Under the	Resource Management Act 1991 (RMA)
In the matter	of a request for rezoning of land in the Kerikeri-Waipapa area under the proposed Far North District Plan

**STATEMENT OF EVIDENCE OF JONATHON MICHAEL RIX IN SUPPORT OF SECTION 42A
REPORT FOR HEARING 15D**

FLOODING

10 September 2025

Figure 1 1% AEP Floodplain (Priority Rivers Model) at Peacock Garden Drive (Source: NRC Natural Hazards portal)

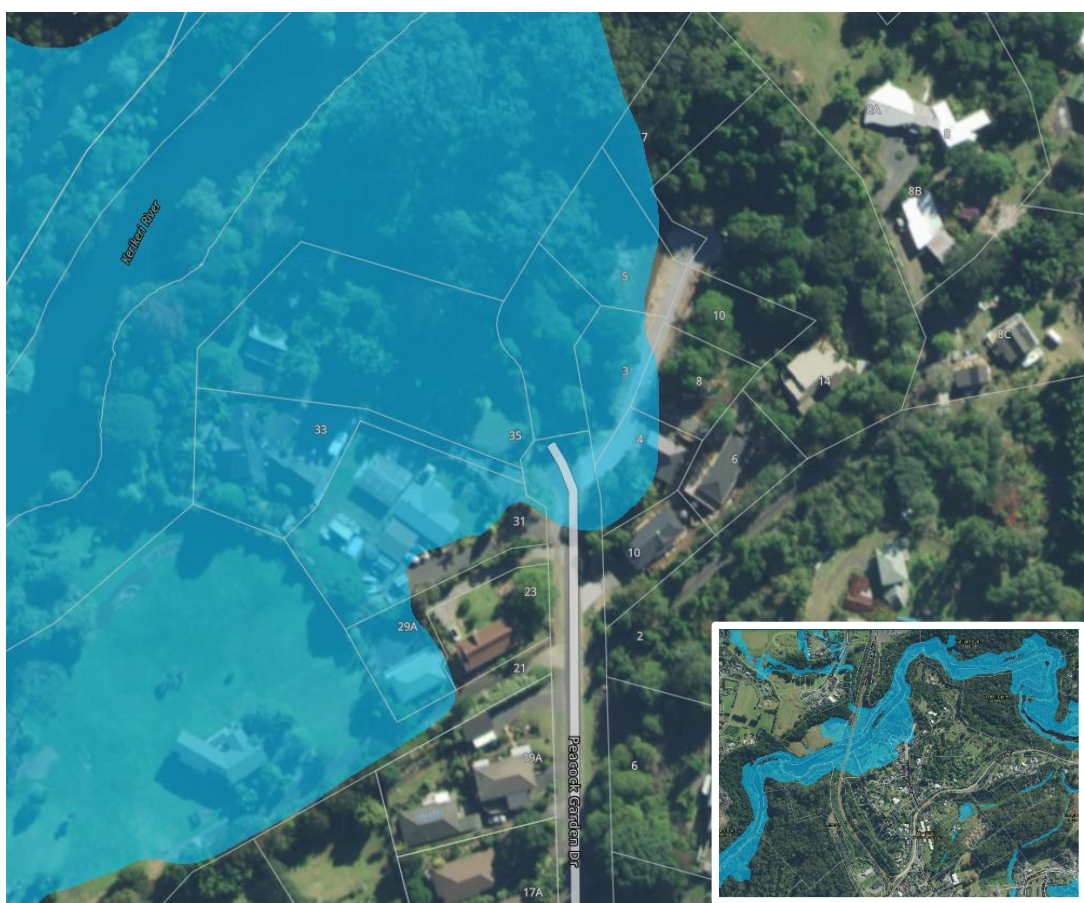
5.33 I refer my earlier comments regarding the high degree of design uncertainty and I consider there to be a risk that future modifications could increase downstream flood flows and water levels further. This could occur if upstream flood conveyance was improved, for example through further channelisation of flows. Typically, the Resource Consent phase will address mitigation of effects. However, I am concerned that changes to the flood mitigation design could materially impact information relied on to support the rezoning decision. Based on the information provided and uncertainty of design I do not support the conclusion by Mr Kuta that the effects are less than minor.
